### **ADDENDUM NO. 3**

**PROJECT NAME: FIRE STATION # 53**

**PROJECT NO.: 20-00045A**

To the drawings and specifications for:  
Fire Station 53  
14102 Donop Road, San Antonio

**A7.1**

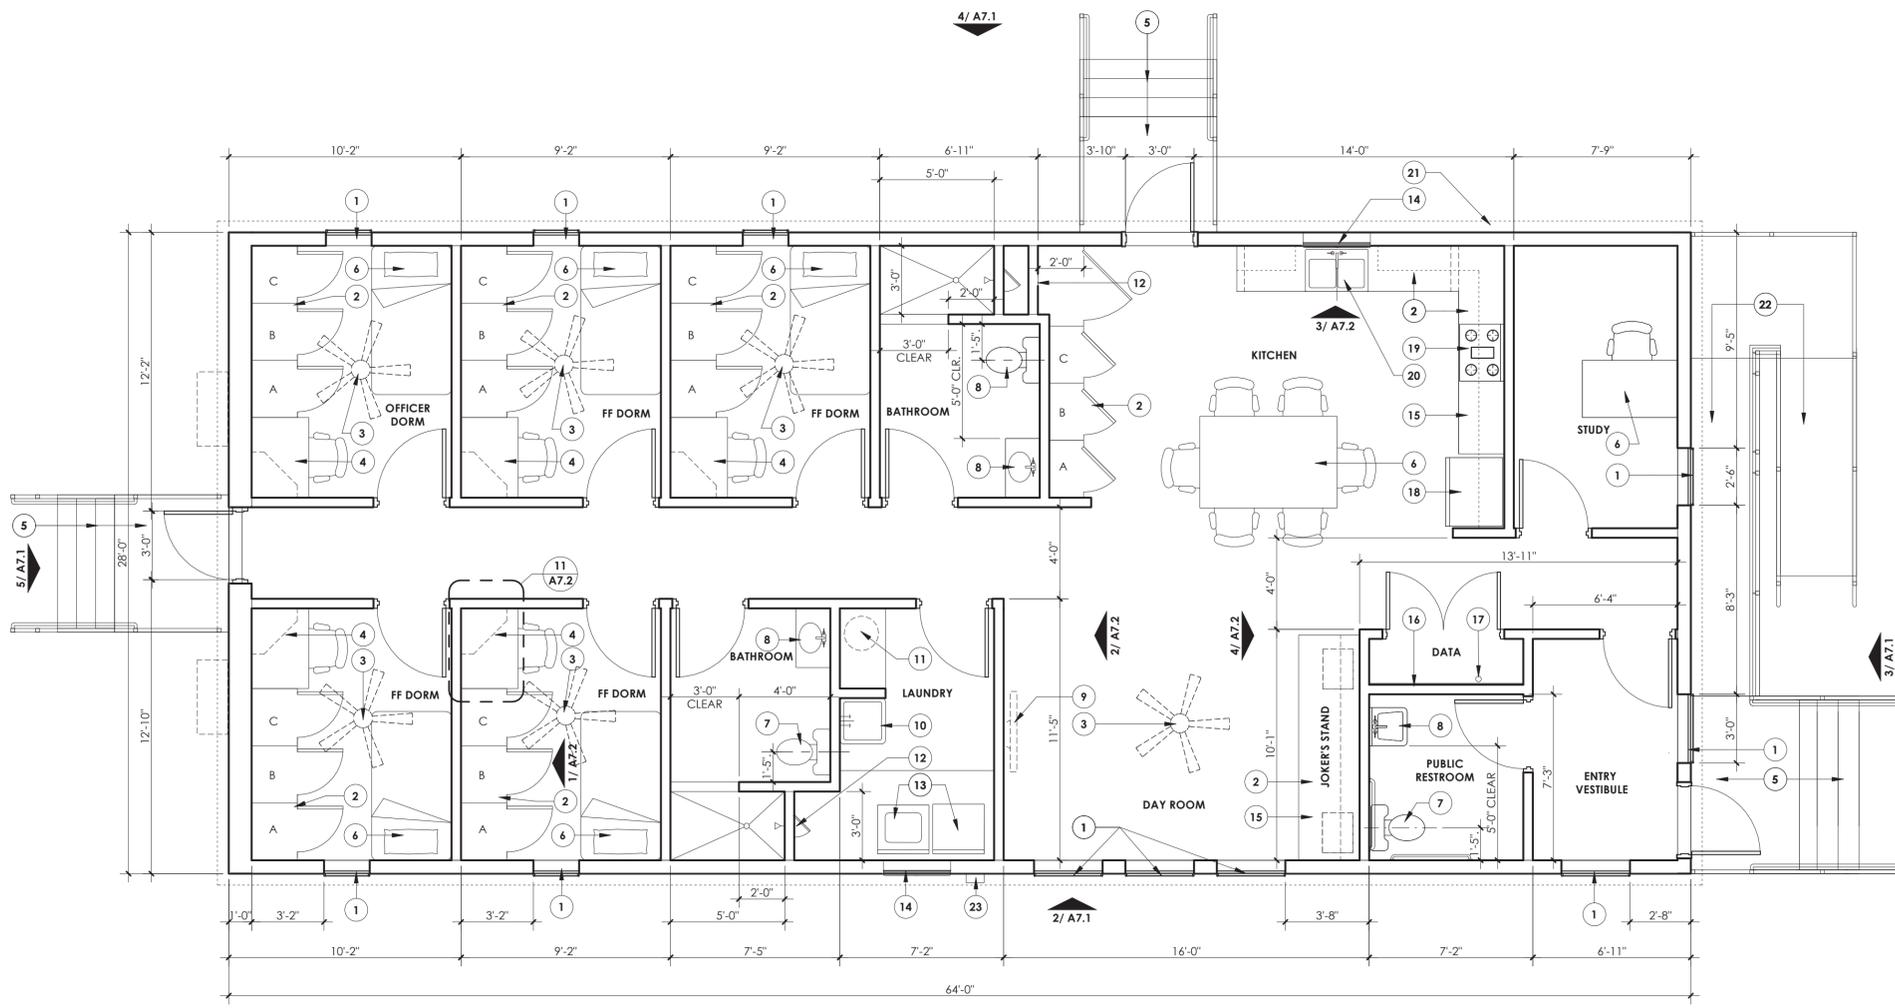
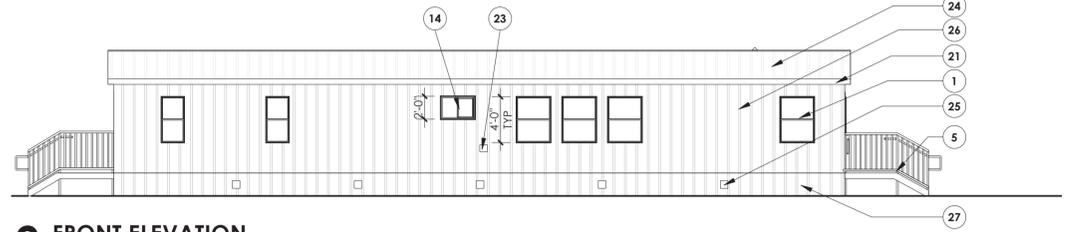
- 3.1 Alternate No. 3 has been added to the construction drawings. For Alternate No. 3, "include the amount to be added to or deducted from the base bid for the provision and installation of a state certified modular building in lieu a manufactured mobile home as indicated in the Construction Documents." Refer to attached Architectural Drawings A7.1, A7.2 & A7.3 seal dated 05.20.2016.
- 3.2 The Bid Form has been updated to include Alternate No. 3.
- 3.3 Sheets A6.1 & A6.2 have been updated to co-ordinate the outline specifications with the revised Bid Form.

A. THE A7 DRAWING SHEETS DESCRIBE THE WORK ASSOCIATED WITH ALTERNATE NO. 3 AS IDENTIFIED IN ADDENDUM NO. 3. THESE SHEETS DEPICT A MODULAR BUILDING SCOPE. MODULAR BUILDINGS AND THEIR CONSTRUCTION ARE REGULATED BY THE STATE OF TEXAS AND FALL UNDER THE TEXAS INDUSTRIALIZED BUILDING CODE COUNCIL. THESE SHEETS DEPICT GENERAL DESIGN SCOPE FOR THE PURPOSE OF BIDDING AND NEGOTIATION AND ESTABLISH THE BASIS FOR DELEGATED DESIGN SCOPE. THEY DO NOT COVER ALL ASPECTS OF THE MODULAR BUILDING REQUIRED FOR CONSTRUCTION AND STATE CERTIFICATION(S). MODULAR BUILDING CONSTRUCTION DOCUMENTS ARE THE RESPONSIBILITY OF THE MODULAR BUILDING MANUFACTURER/INSTALLER AND THEIR REGISTERED PROFESSIONAL ENGINEER OR ARCHITECT. REFER TO SPECIFICATION SECTION 131650 FOR ADDITIONAL MODULAR BUILDING INFORMATION ON DELEGATED DESIGN.
